TOWN OF CARMEL
PLANNING BOARD

PLANNING BOARD AGENDA
JULY 11, 2018 – 7:00 P.M.

RE: EMTK Realty Site Plan
1736 Route 6
Tax Map No. 44.18-1-40

RE: Amended Site Plan for Alexandrion Group/Hinckley Holdings, LLC
Tm# 55.10-1-1, 3, and 55.6-1-53

OVERALL SITE PLAN

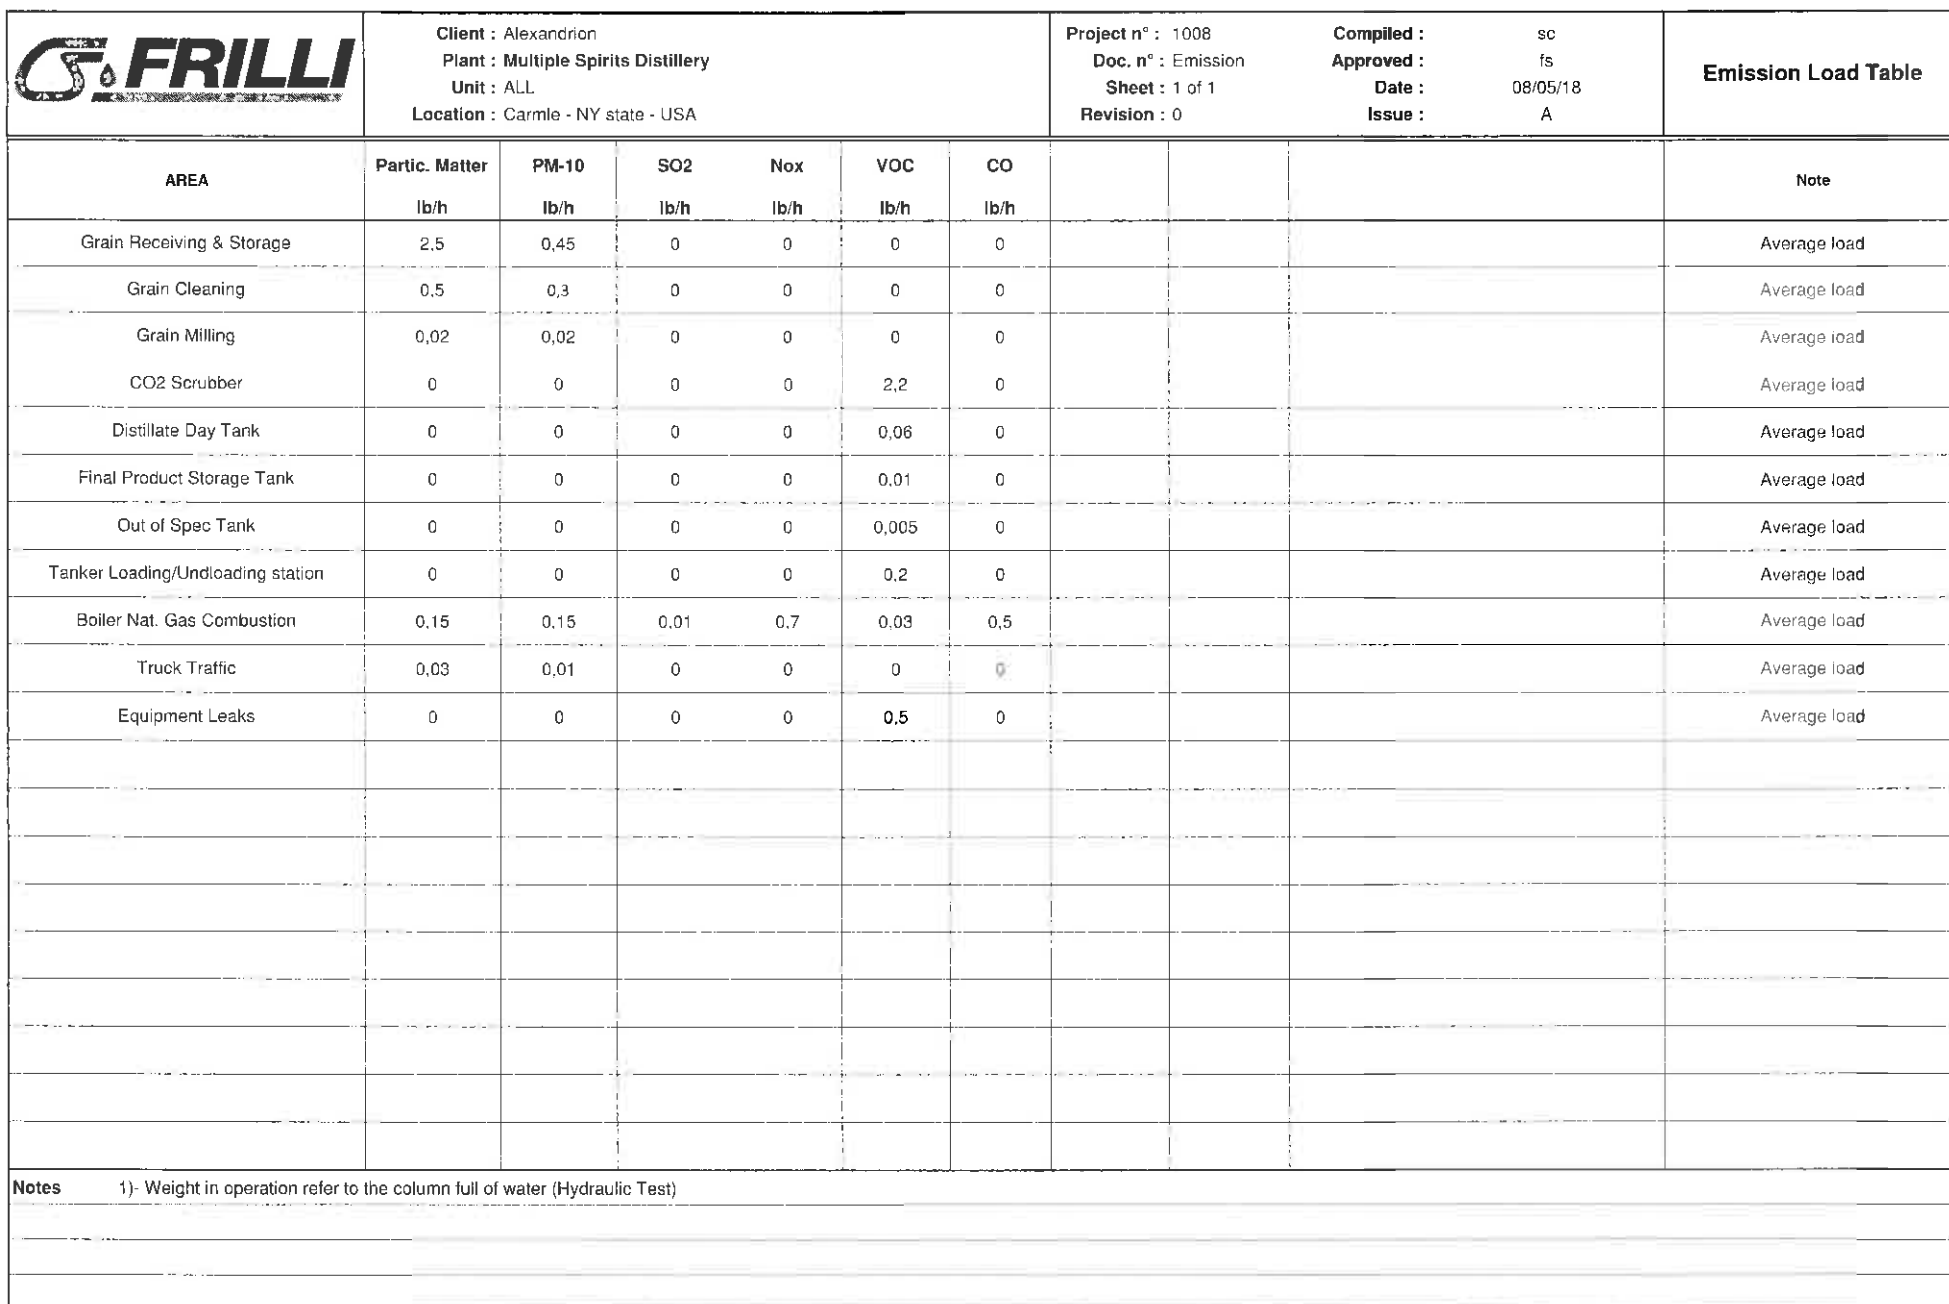
Provide a Zoning Table. Lot area, lot width, lot depth, building height, coverage, setbacks, etc..

3. Graphic representation of vehicle movements through the site must be provided to illustrate that sufficient space exists to maneuver all types of vehicles anticipated at the site. All turning radii for the site must be graphically provided. All turning radii shown on C-201.

Zoning table provided on Sheet C-100 with this submittal dated 7/3/2018.

OVERALL EROSION AND SEDIMENT CONTROL PLAN

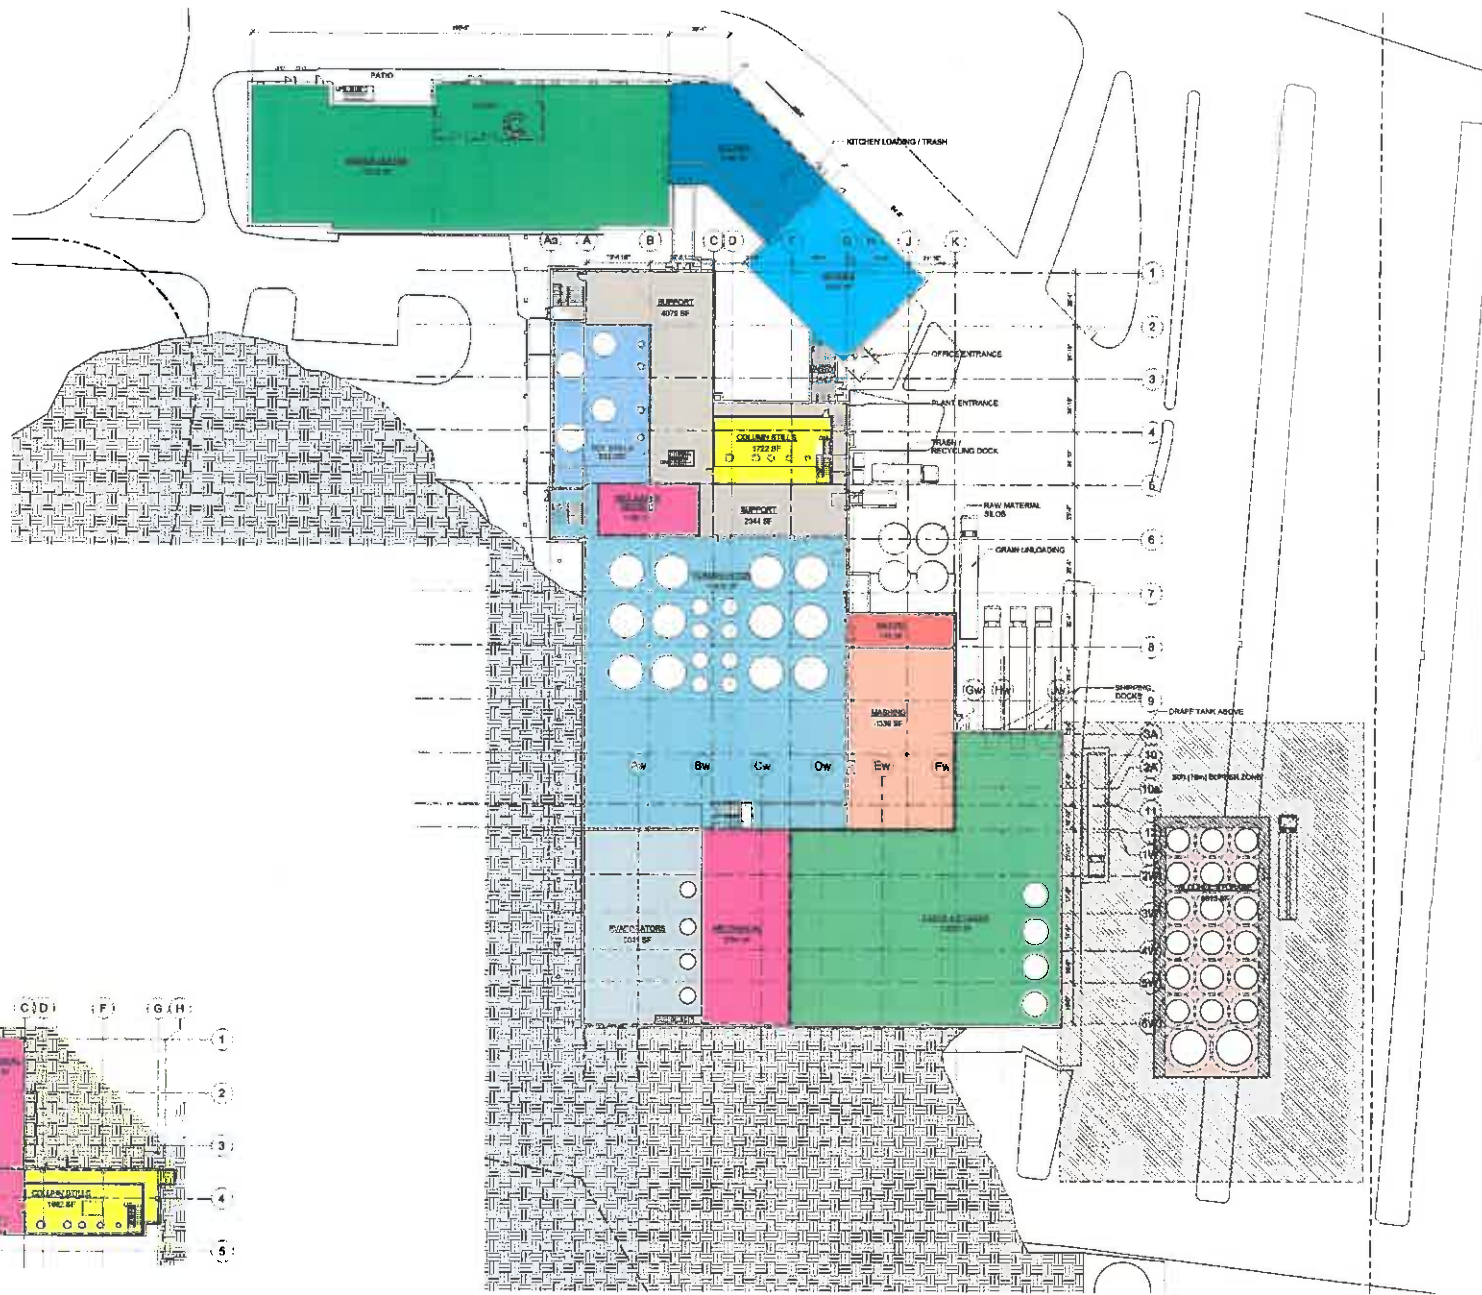
4. The overall disturbance for the project as submitted is 42,818 sq-ft which therefore exceeds the threshold criteria of disturbance for New York State Department of Environmental Conservation (NYSDEC) stormwater regulations. This project is above the 5,000 sq ft threshold and below the 1 acre threshold and therefore requires coverage under the NYSEC SPDES General Permit for Stormwater Discharges from Construction Activity (GP-0-15-002) and the development of SWPPP that includes only erosion and sediment control and not permanent stormwater features.
SWPPP and Erosion and sediment control plan provided on C-400 and C-401.

4. Available sight distances at each driveway location should be specified on plan. Any clearing along the edge of the roadway R.O.W. that may be necessary to assure appropriate sight distances are provided, must be identified. Clearing has been identified on C-400.

7. Sheet 401 provides details for tree protection, temporary sediment trap, erosion blanket however the location of these features is not provided on site plan drawing. **Details revised.**
8. A copy of the SWPPP must be provided for review. **SWPPP provided on C-402.**
9. A construction sequence must be provided. **Provided on C-402 with SWPPP.**
10. All asphalt for roads (not being dedicated to Town)/parking/driveways should have a top layer of pavement at 2 inches, the binder course at 3 inches and the subgrade at 8 inches. Details must be provided for review. **Details provided on C-500.**
